SUBJECT: ** REVISED** 2006 HAWKEYE 2x4 / 4x4 / Intl - Front Bearing Carrier Replacement and Steering Post Support Bracket Installation

Service Bulletin ATV-07-01A: Affects all units produced prior to January 23, 2006. These ATVs need to have both the "Front Bearing Carrier Replacement" and "Steering Post Support Bracket Installation" performed.

AFFECTED MODELS: ATV-07-01A - Front Bearing Carrier Replacement / Steering Post Support Bracket Installation

PARTS INFORMATION: ATV-07-01A Steering Post Support Bracket Installation

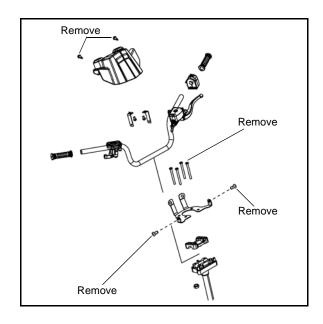
ATVs affected by this Safety Bulletin also have steering posts which may fatigue and break in the area where the handlebar attaches to the steering post. Failure of this component may lead to loss of steering control resulting in an accident and serious personal injury to the operator. A Support Bracket Kit has been developed to address this issue.

PART NUMBER / DESRIPTION	2203644 / Steering Post Support Bracket Kit
PARTS AVAILABILITY	Week of May 28, 2007
QUANTITY (Per Affected Unit)	QTY 1 - Support Bracket Kit
DIRECT-SHIP FROM POLARIS?	NO
TO BE ORDERED BY DEALER?	YES
